21420 NOVI ROAD (FORMER BORDER CANTINA) JSP25-17

Consideration at the request of Kap and Rich Restaurant Group for approval of Preliminary Site Plan, Landscape Waivers, and a Section 9 Façade Waiver. The subject property at 21420 Novi Road totals approximately 1.73 acres and is located east of Novi Road, south of Nine Mile Road (Section 35). The property is zoned B-3: General Business District and P-1: Vehicular Parking District. The applicant is proposing building and site renovations to support the new restaurant use.

PLAN REVIEW CENTER REPORT

Preliminary/Final Site Plan

PROPOSED
SITE PLAN

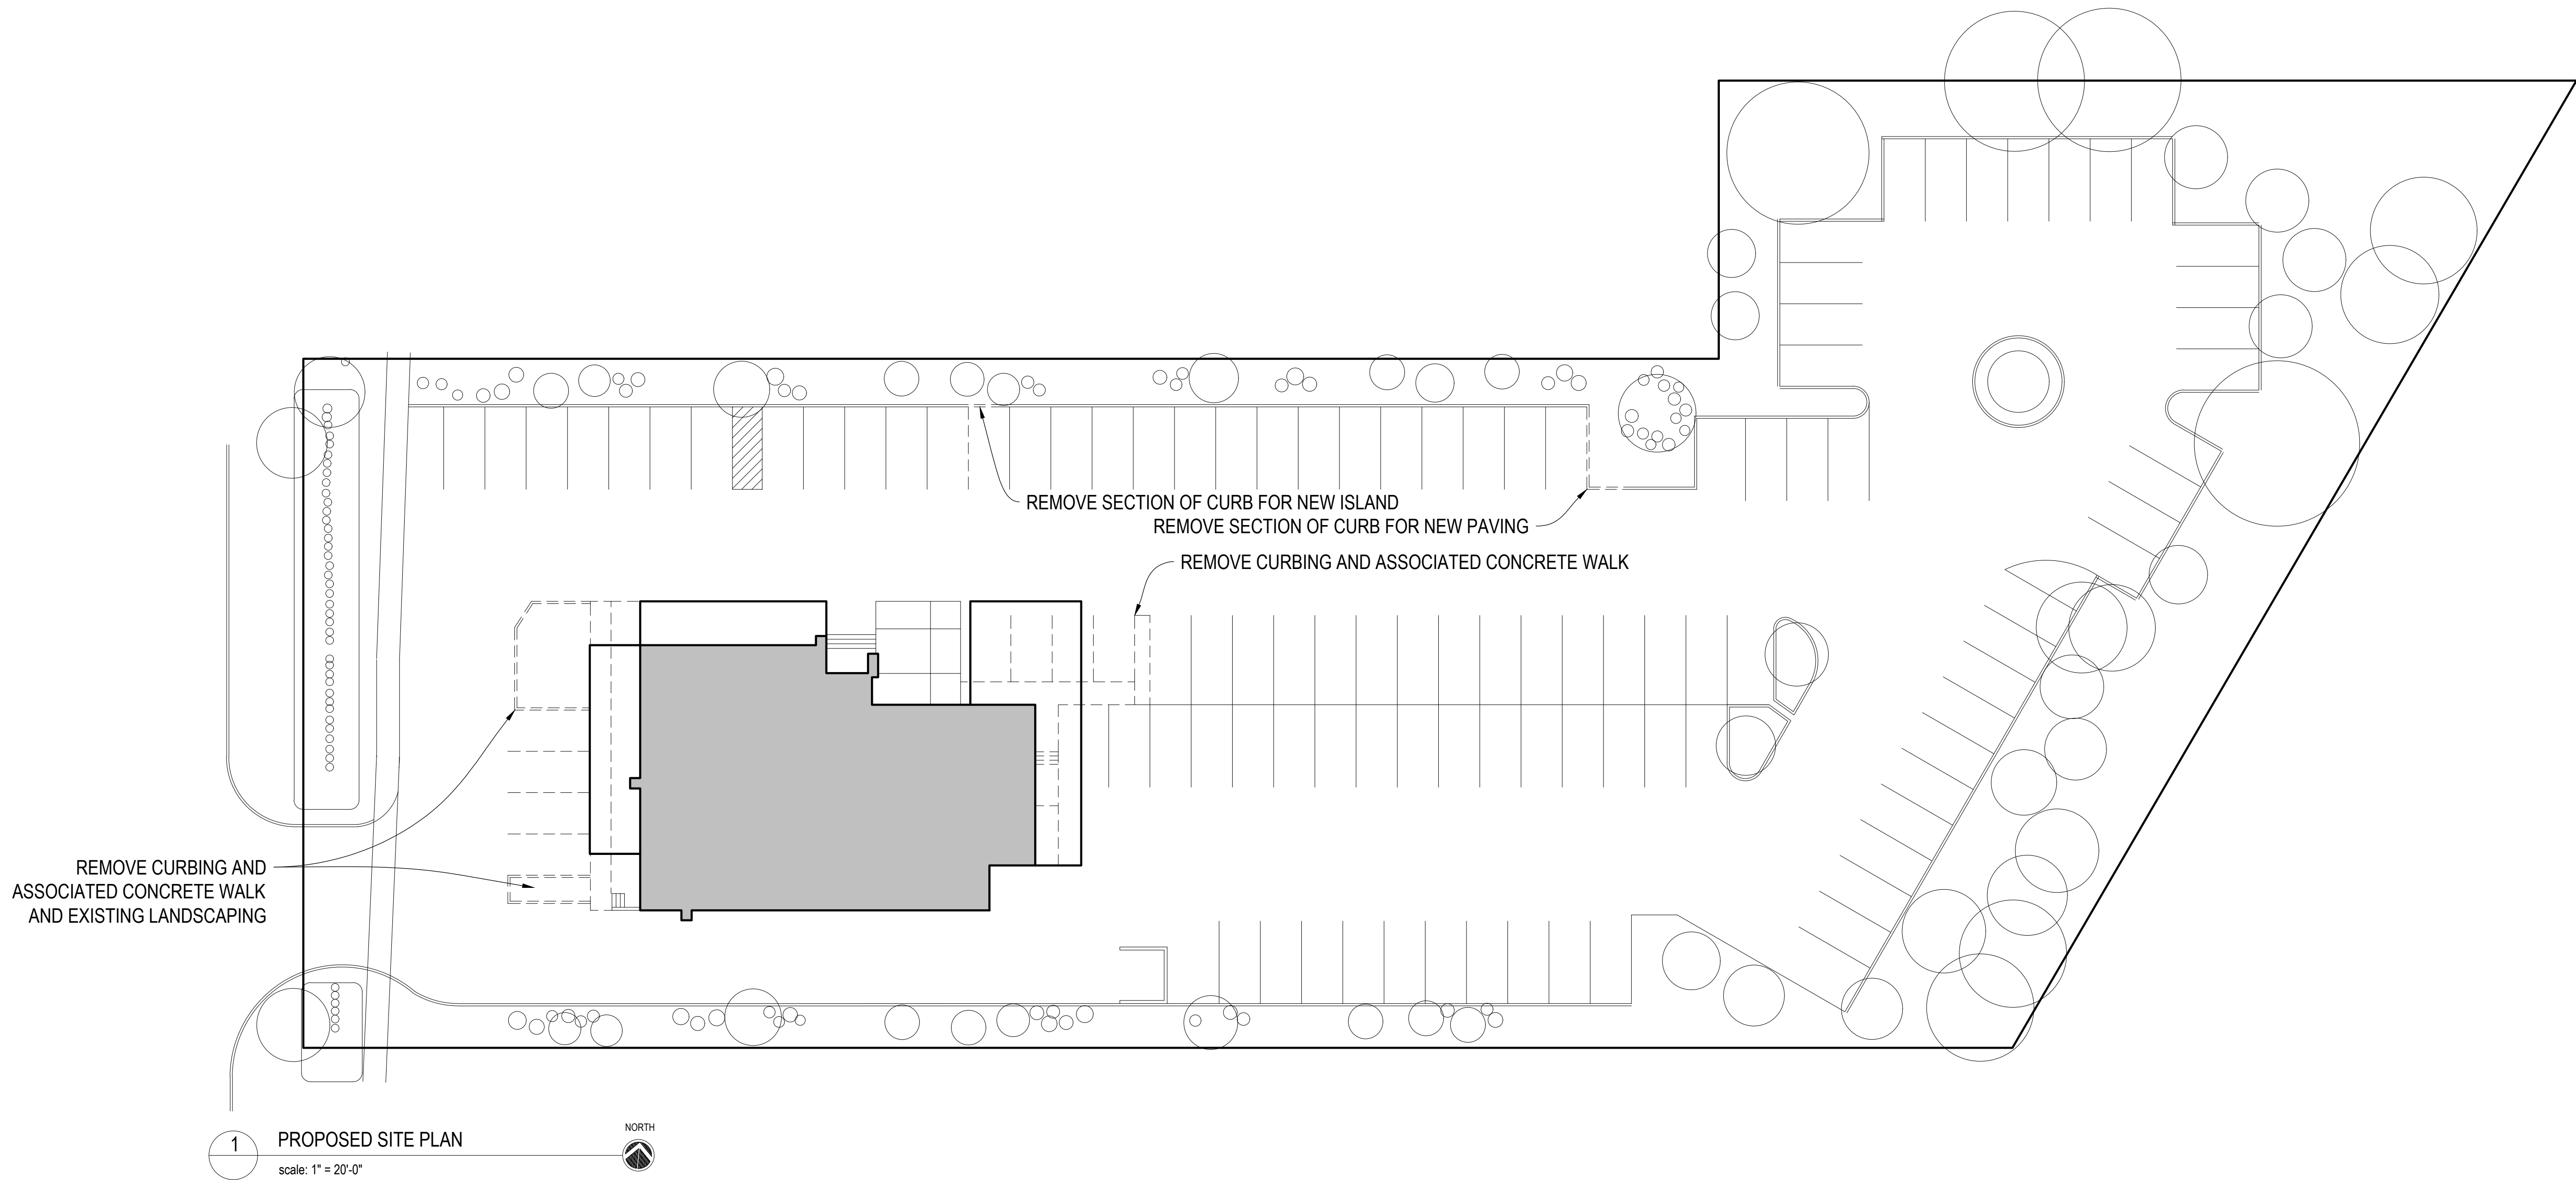
- 90° parking, 9 feet wide by 18 feet long parking spaces with 6" high curbs proposed. **Please provide 4" curb instead of 6" for parking spaces less than 19 feet.**

1. Provide a note on sheet SP101 that all work shall conform to the current **City of Novi standards and specifications**.
2. Clearly distinguish between proposed improvements and existing features of the site. Hatch any pavement that will be reconstructed due to removal of curbing, sidewalk, etc.

- A maneuvering lane of 20'-4 ½" on the south side of the building is existing non-conforming.
 - The addition to the rear of the building creates a reduced drive aisle of 20'-9 ½" adjacent to the existing dumpster. **Please relocate the dumpster to meet the required drive aisle width or a variance will be required. The dumpster was relocated and shown on sheet SP 101**

1 SOUTH ELEVATION
scale: 1/4" = 1'-0"

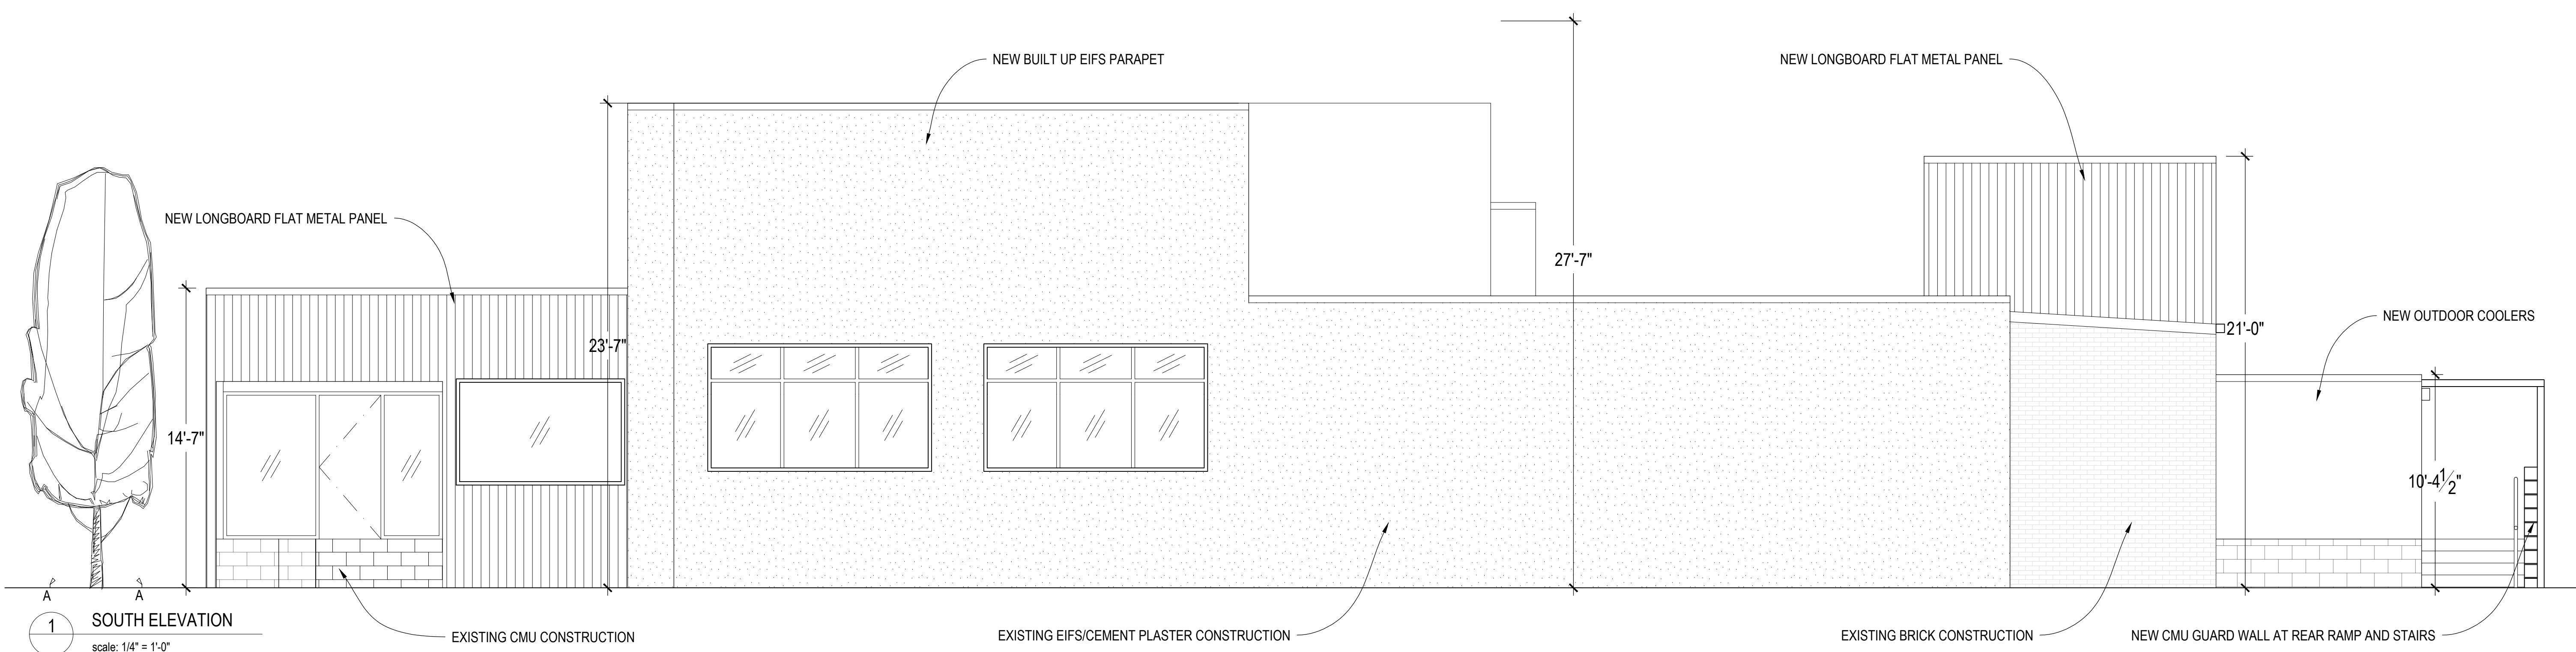
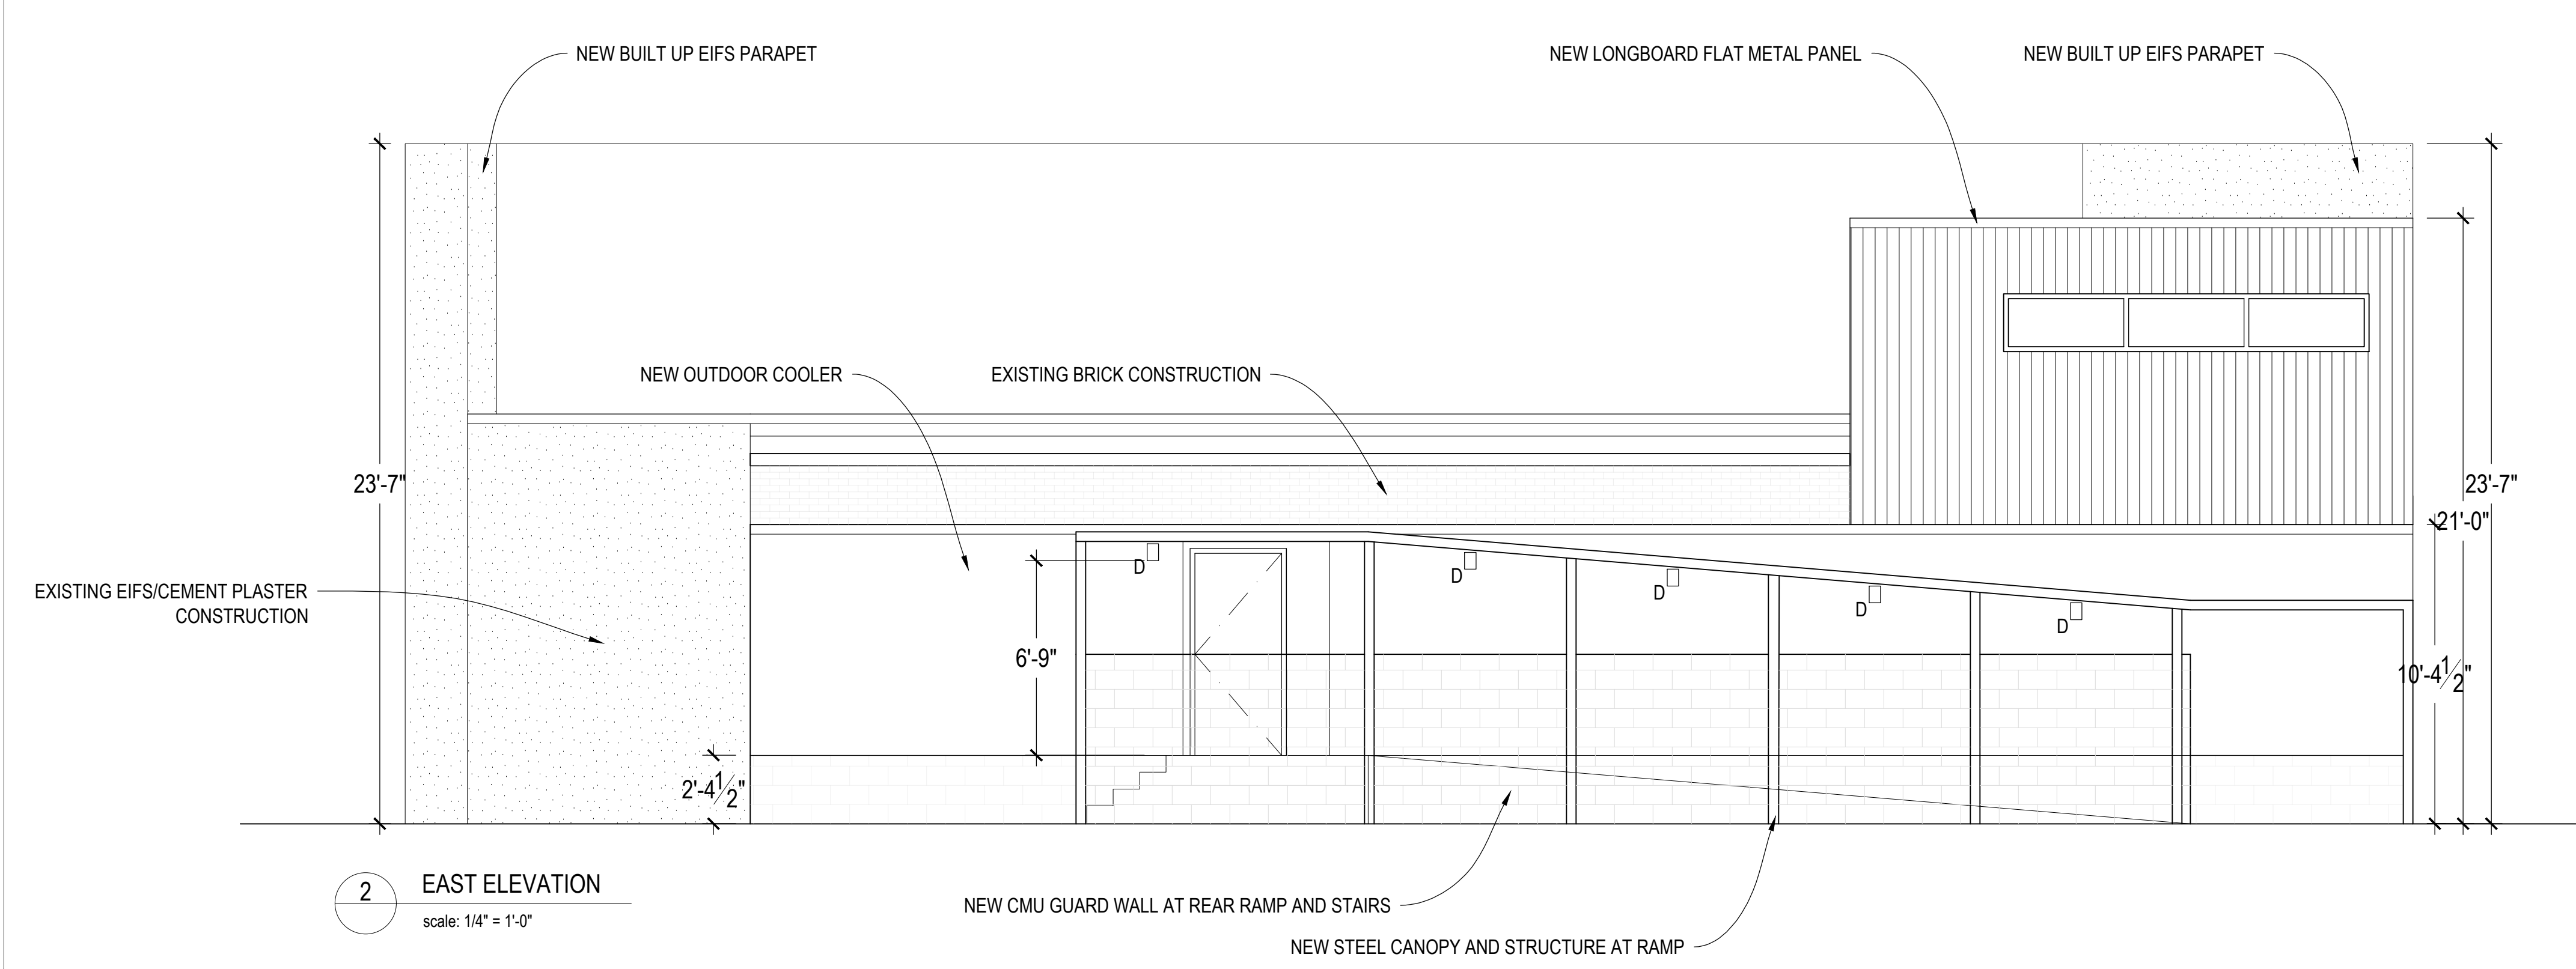
9. Façade Modifications (Section 5.15.6): Where new materials are proposed for an existing building facade, the entire building facade shall be subject to Section 5.15 standards. The underage of brick and overage of CMU are permitted as a continuation of existing materials. **A Section 9 Façade Waiver is required for the overage of EIFS. The waiver is supported contingent on an approved sample board.**

- h. A Section 9 Façade waiver, under Zoning Ordinance Section 5.15.9, is granted for overage of EIFS (69% proposed on south elevation, 50% proposed on east elevation, 25% permitted).
